Director's Report

Project Name: Edendale

Description: Final Site Plan Approval

RE: Edendale Crossing
Final Site Plan Submission

Bogie Lake Road Entrance Plan
"EDENDALE CROSSING" SITE CONDOMINIUM
PART OF THE SOUTHEAST 1/4 OF SECTION 29, T3N, R8E
WHITE LAKE TOWNSHIP, OAKLAND COUNTY, MICHIGAN

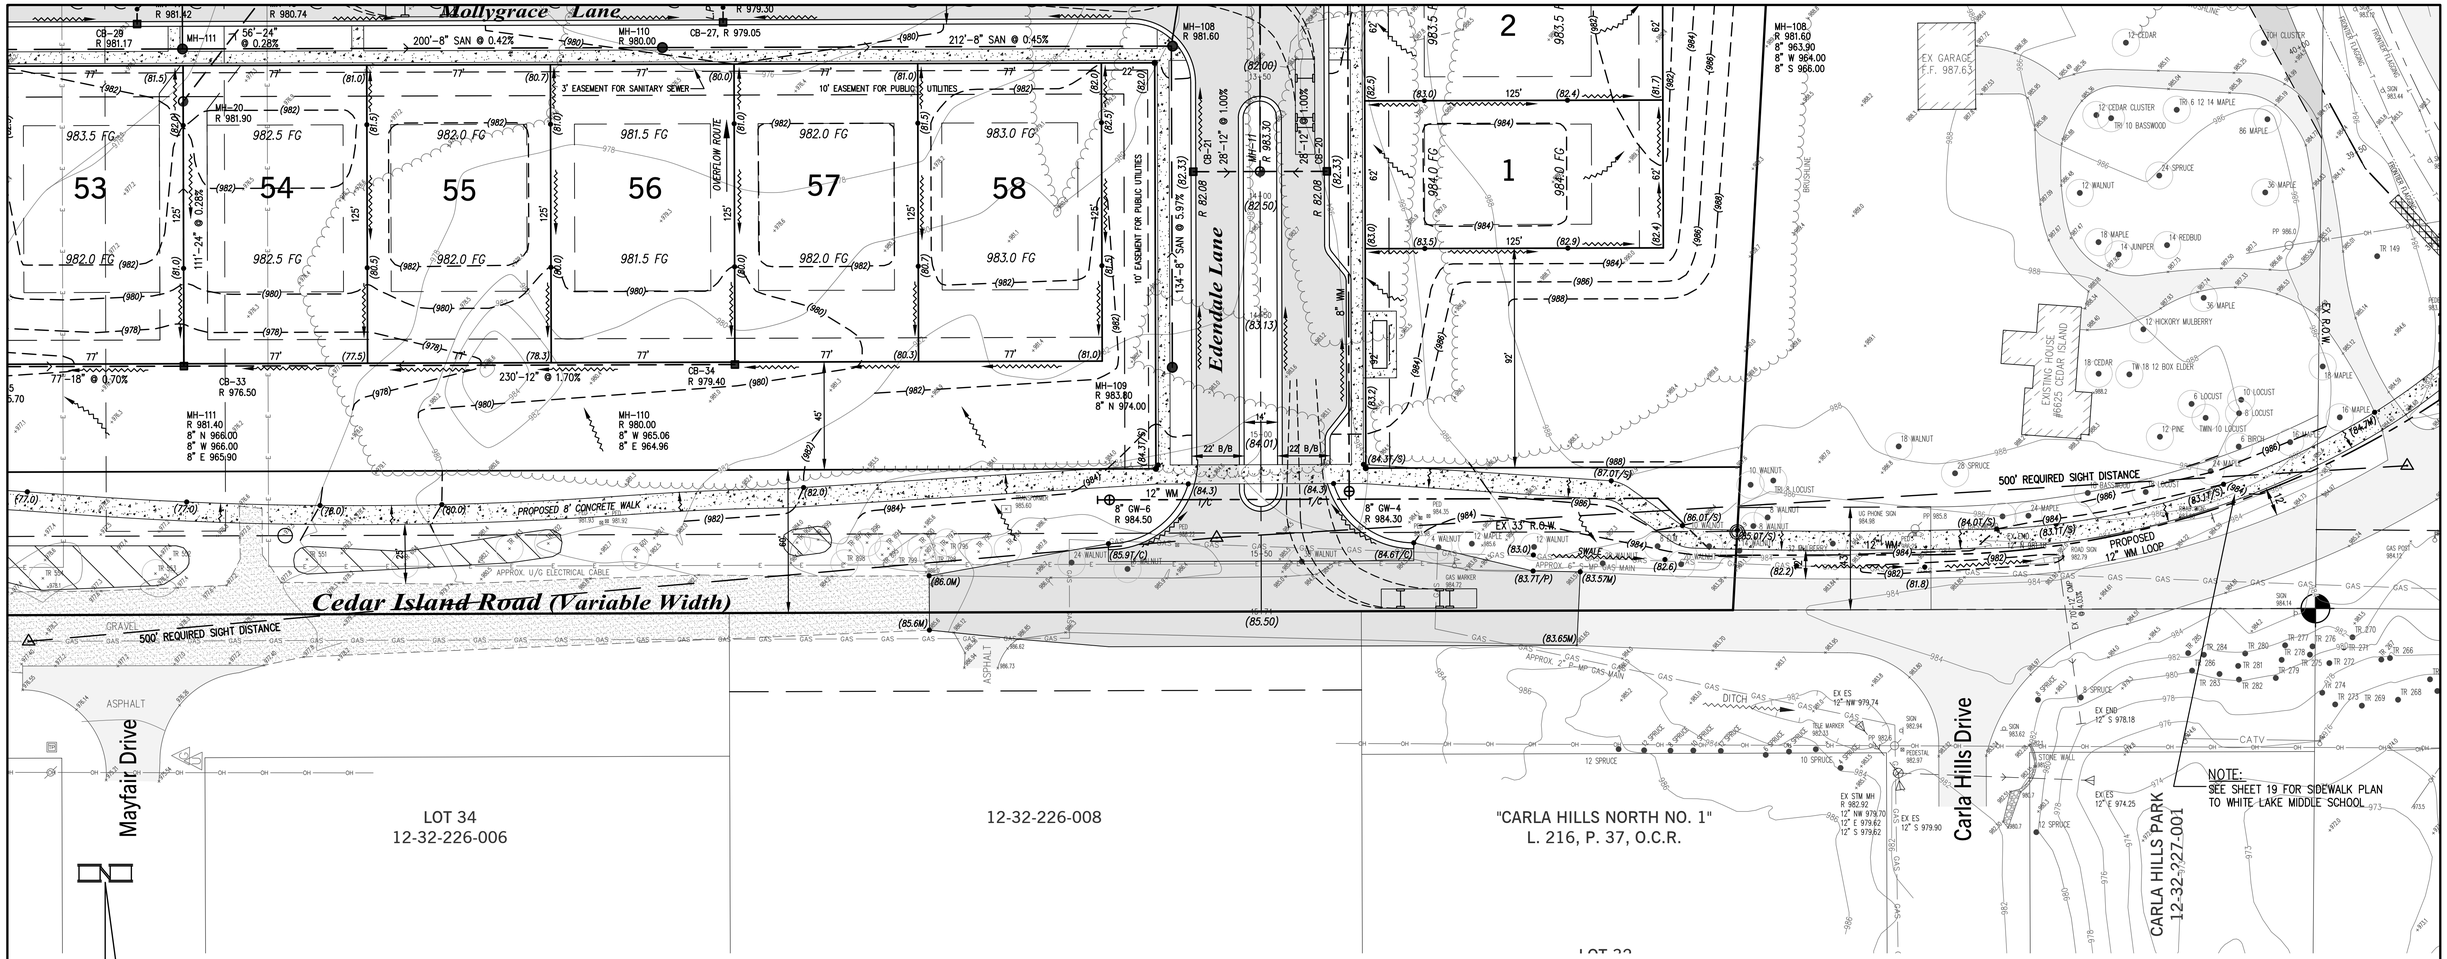
1. *Sheet 8- It appears the discharge from the detention pond will flow across Parcel #12-28-303-001 which may require a storm drainage easement unless the storm sewer can be extended to a point there is no conflict. Comment addressed. A ditch that will route where the drainage to Thompson Lake goes is now proposed within the existing road ROW.* **Comment remains as a notation.**

2. *Sheet 8- The proposed storm sewer layout along Bogie Lake Road will need to be* ***clarified at the time of ~~Final Site Plan/~~Final Engineering Plan*** *to work with existing stormwater features, site drainage, and utility poles etc.* **Comment remains as a notation.**

Cedar Island Entrance Plan
"EDENDALE CROSSING" SITE CONDOMINIUM
PART OF THE SOUTHEAST 1/4 OF SECTION 29, T3N, R8E
WHITE LAKE TOWNSHIP, OAKLAND COUNTY, MICHIGAN

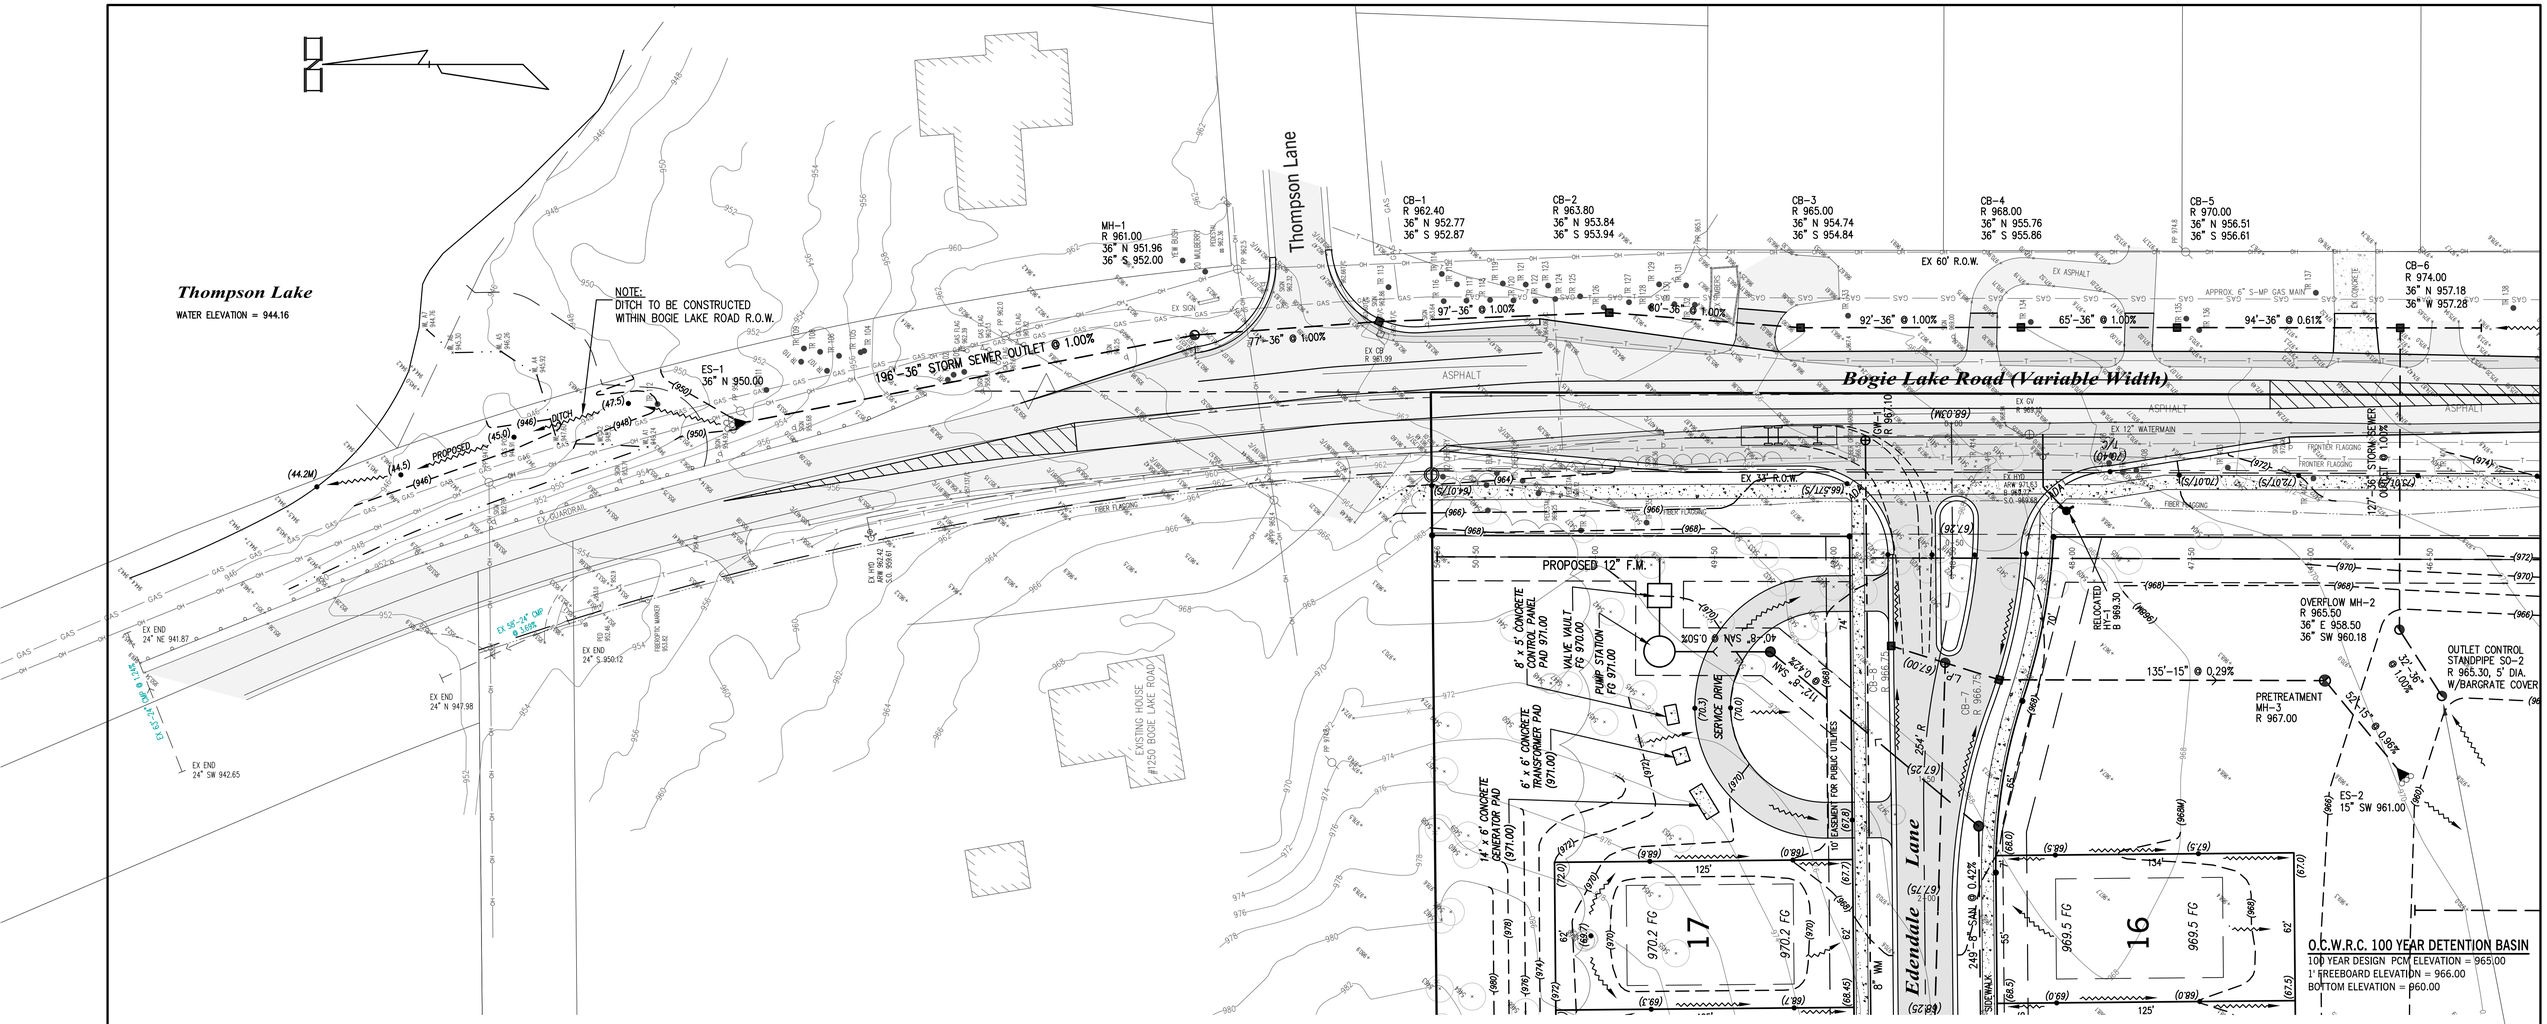
6. *Sheets 5 and 9- Entrance dimensions of Edendale Lane at Cedar Island Road do not correspond to 21' B/B and 16' (island width) when measured per provided scale. Please revise.* **Entrance dimensions have been adjusted to 22' B/B widths.**

Detention Basin Calculations & Details "EDENDALE CROSSING" SITE CONDOMINIUM

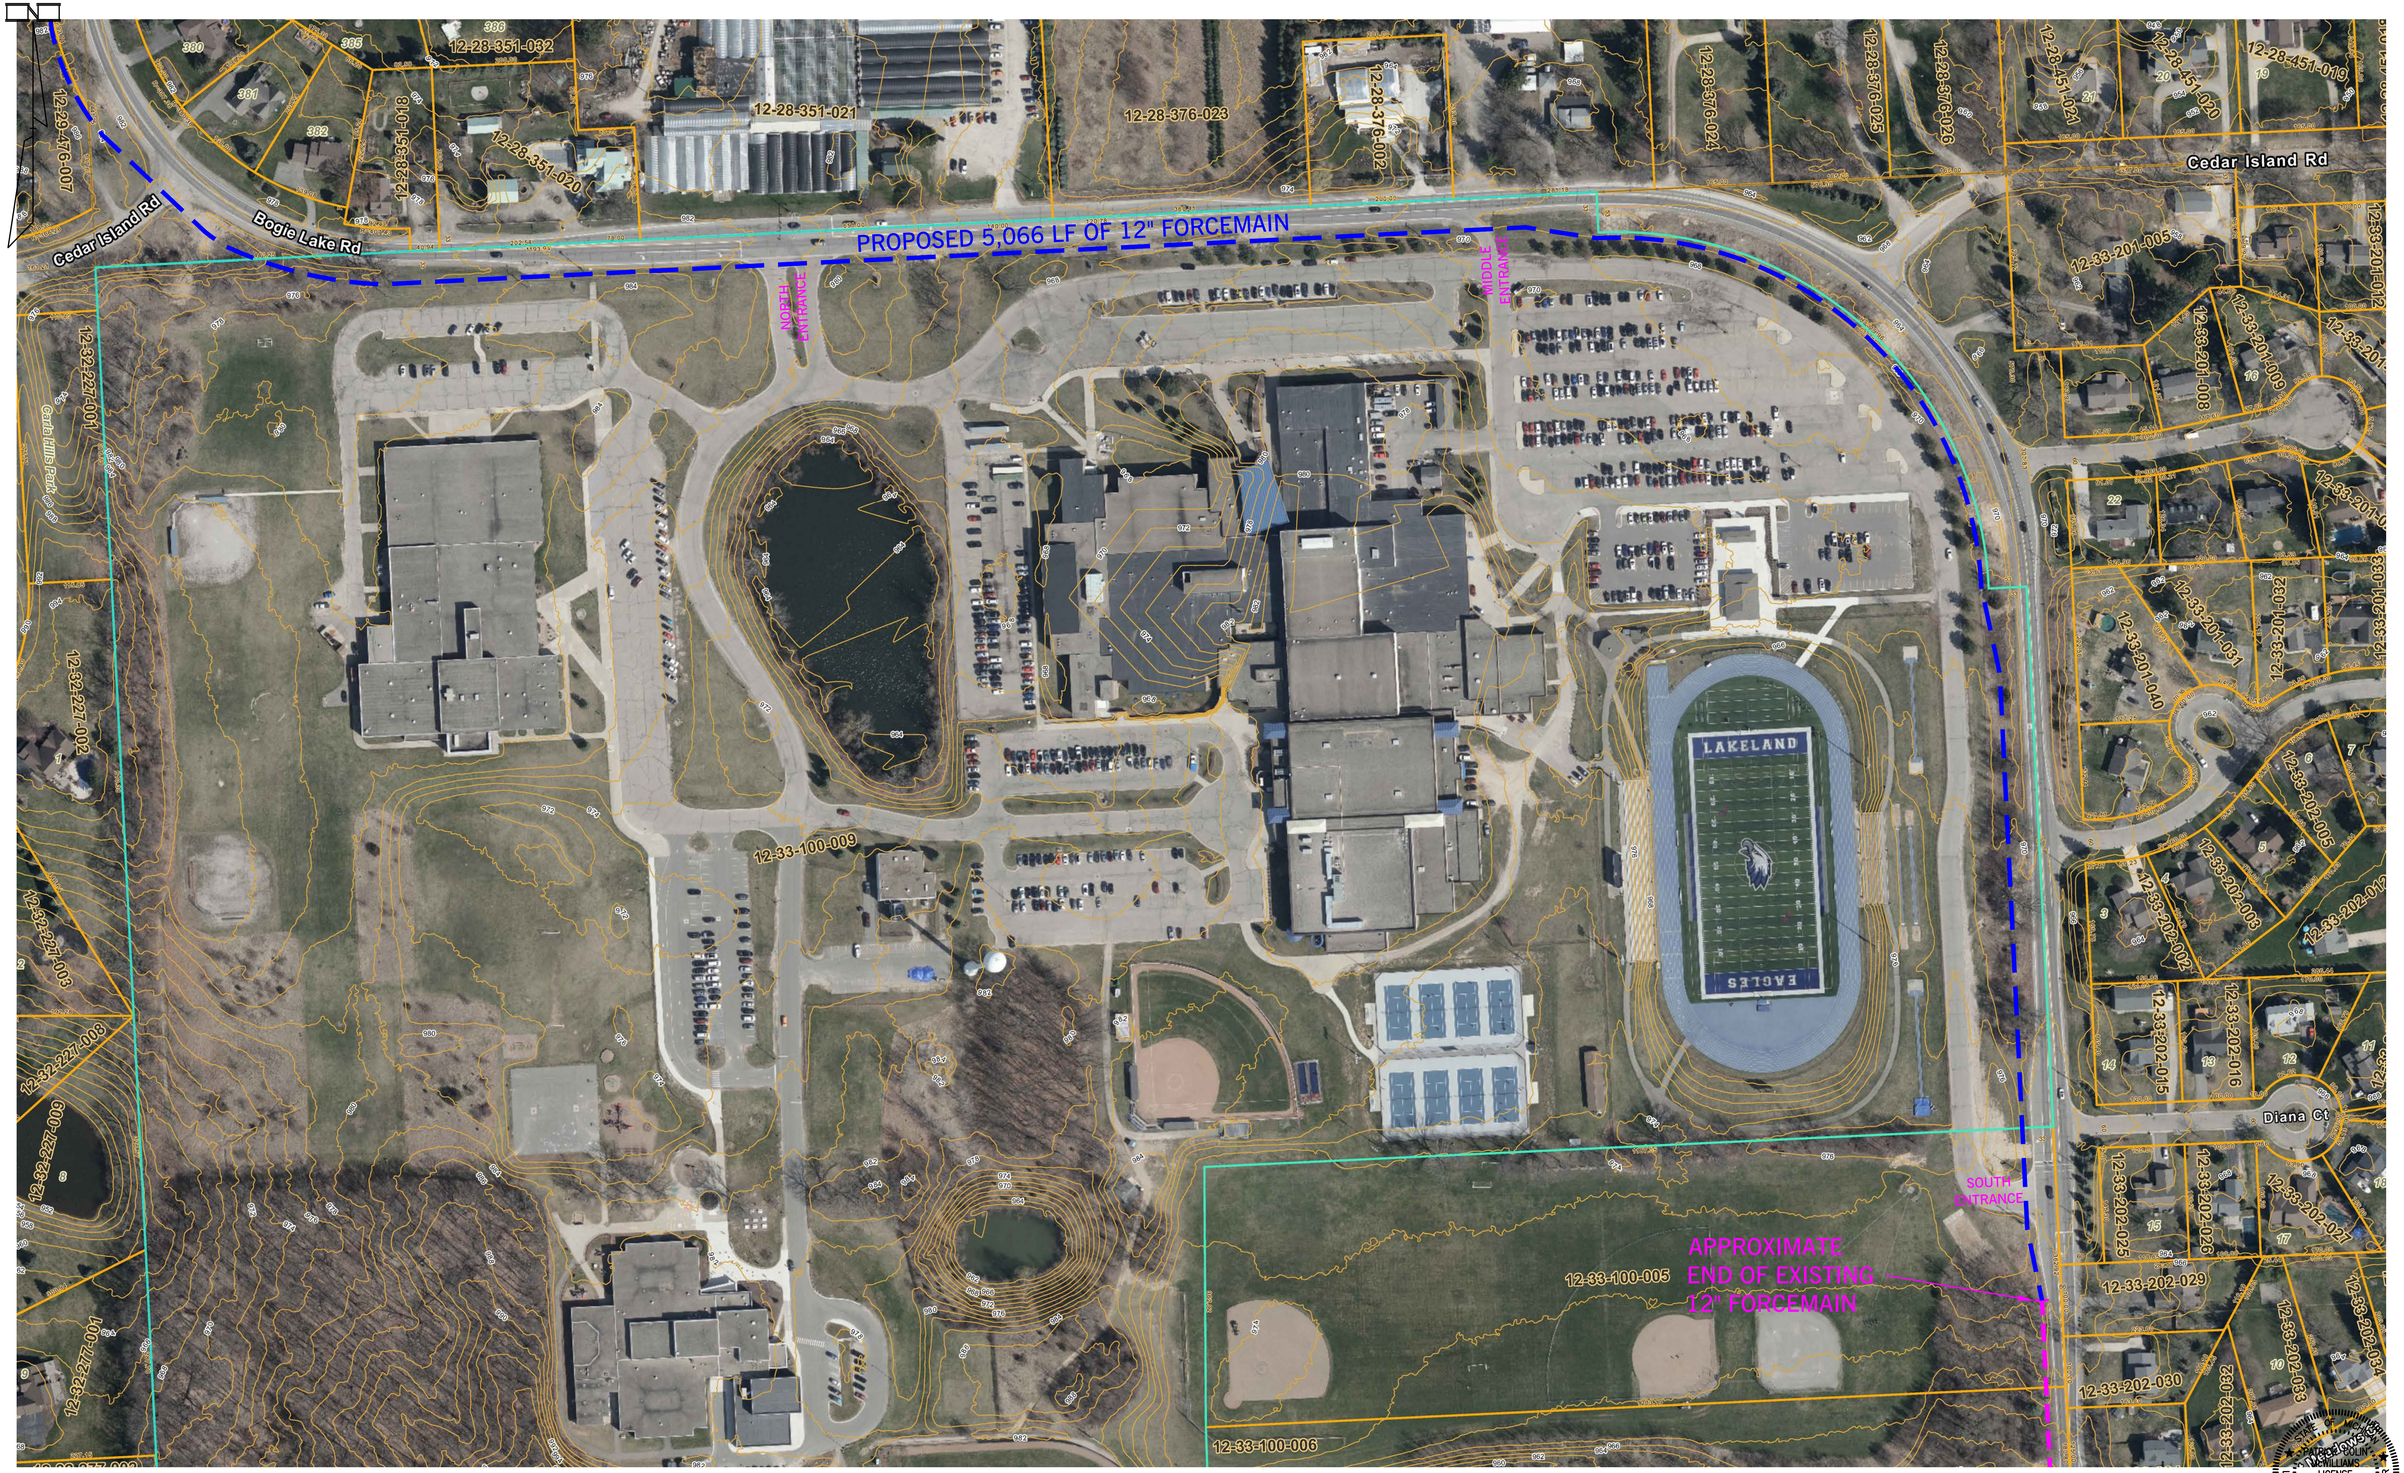
1. Sheet 11- Please see marked up calculations for revisions that shall be required.
2. We note that the location of the proposed sanitary pump station has changed from the Township Board approved Preliminary Site Plan. We consider the revised orientation to be an improvement compared to what was previously indicated so we do not take issue with this item but wanted to note the change.

Does not match C (0.41)provided on Sheet 3

Shown on Sheet 3 as 3.20 acres

In addition, Sheet reference note on Sheet 3 references Sheet 16; it should be Sheet 11.

Stormwater calculations:	100-year basin calculations have been revised and are provided on Sheet 11
